## AMENDMENT TO THE INVITATION TO TENDER

RCMP B Block Redevelopment

ADDENDUM NUMBER: ONE

PROJECT: B Block Re-Development

**AR02**

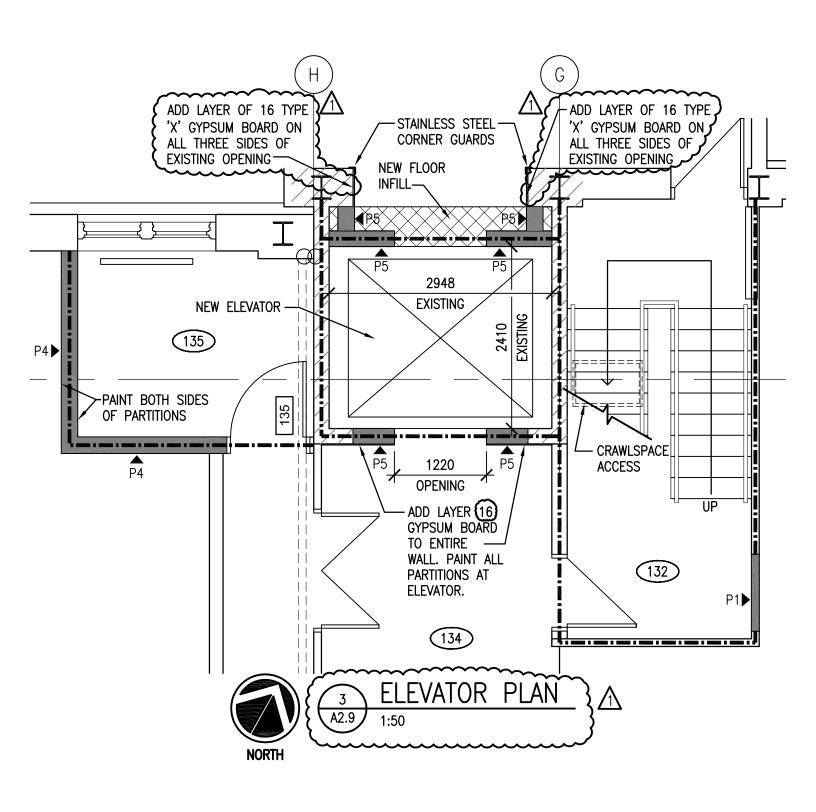
- .1 Reference Glazed Screen Schedule; REVISE GS15, GS16, GS17, GS19, and GS20 as indicated on attached sketch AR02.
- .2 Reference Partition Schedule; DELETE Partition Type 1a.
- .3 Reference Partition Schedule; CLARIFICATION; the overall thickness of Partition Type 2 should read 137mm.

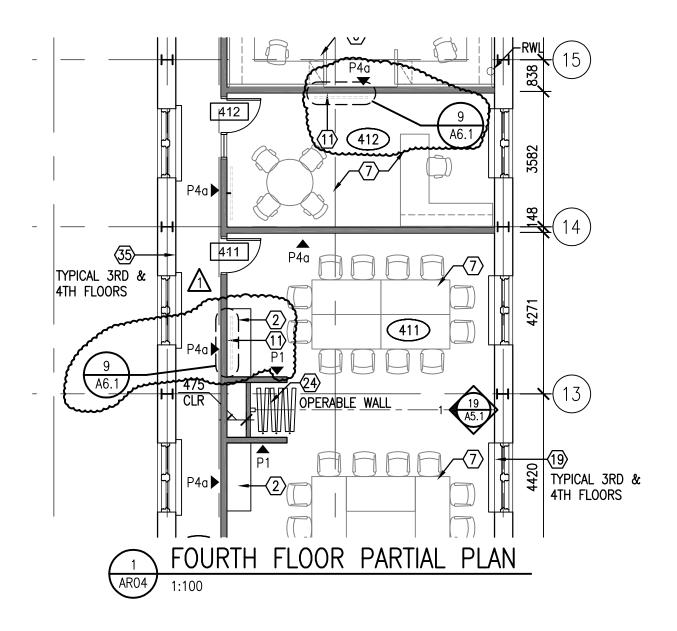
- Reference Drawing 3, Elevator Plan; ADD a layer of 16 type 'x' gypsum board to the existing elevator opening as indicated on attached sketch AR03. REVISE drawing scale annotation as indicated.

DRAWING TITLE PERIMETER WALL DETAIL - FIRST FLOOR 05/2013

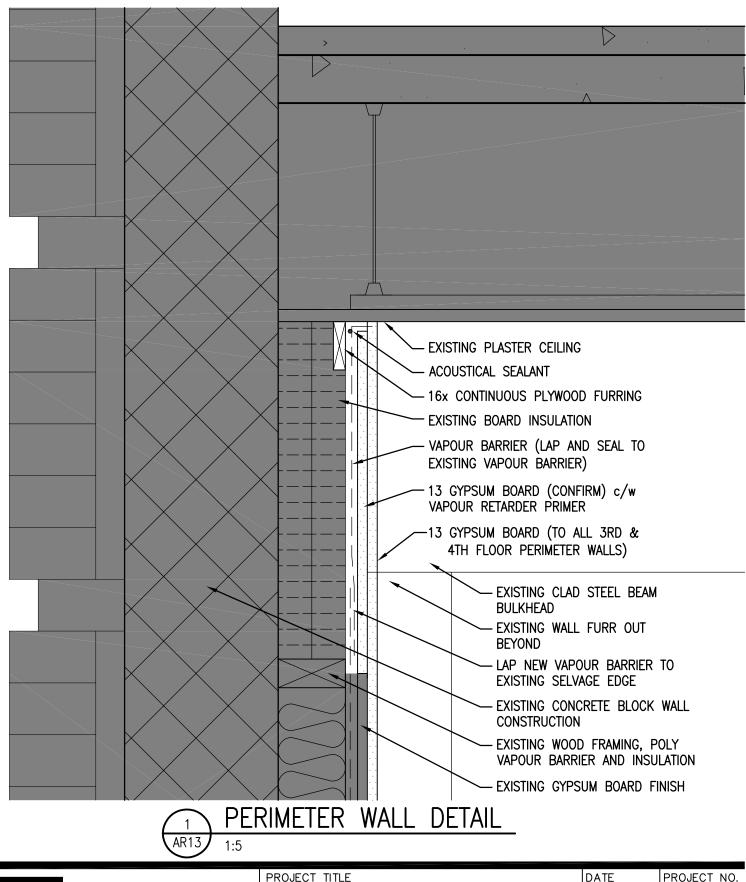
.1 Reference Drawing 1, First Floor Reflected Ceiling Demolition Plan; Refer to attached sketches AR12 and AR13 for perimeter wall repairs required above existing bulkheads.

AR13

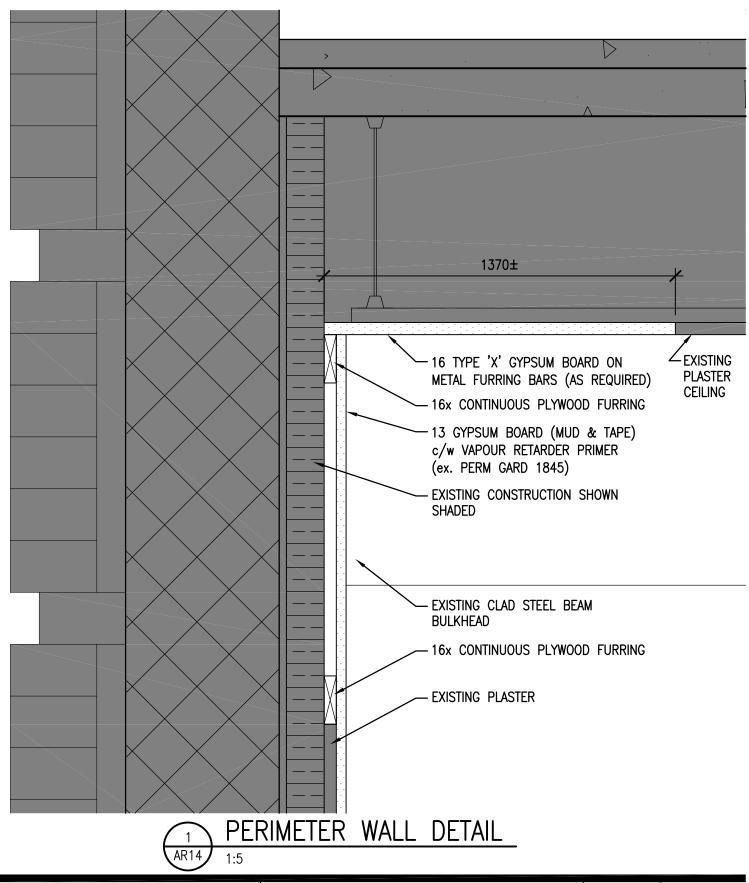
.1 Reference Drawing 1, Third Floor Reflected Ceiling Demolition Plan and Drawing 1, Fourth Floor Reflected Ceiling Demolition Plan; Refer to attached sketches AR12 and AR14 for perimeter wall repairs required above existing bulkheads.

E5.2-R1

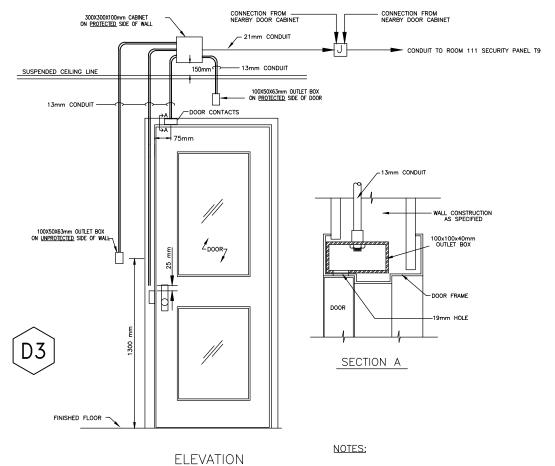
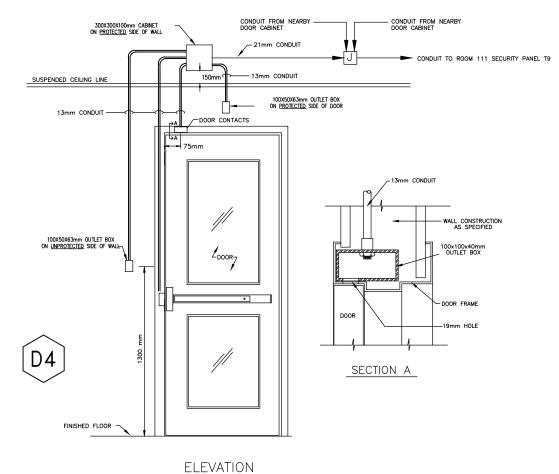
A1-39	REF. DRAWING E3.1	
.1	REVISE access control as per details shown on sketch E5.2R1 included in thi Doors 123, 142, 229 & 246 shall have components changed to those of door to	
A1-40	REF. DRAWING E3.2	
.1	REVISE Door 375: Remove all access control components.	
A1-41	REF. DRAWING E3.3	
.1	REVISE Room 407: Provide data and power to desks in classroom as per sup drawing E3.3R1.	plemental
.2	REVISE Room 409: Remove 'TV' audio/visual outlet located on south wall of meeting room.	
.3	REVISE Room 409: Voice outlet shall be changed to 'a' above counter height	
.4	REVISE Room 412: Provide 'TV' audio/visual outlet on north wall of office. Outlet shall be 2500mm east of west wall. Provide HDMI jack located near other data/voice drops on south wall for desk area. Run 35C to ceiling space from both TV outlet and HDMI jack.	
.5	REVISE Room 417: Single voice outlet mounting height shall be changed to A.F.F.	1500mm

- .1 ADD sketch E5.2R1 for access control door hardware details.
- .2 REVISE Details 3 & 7: Replace the following room names with the associated room numbers:
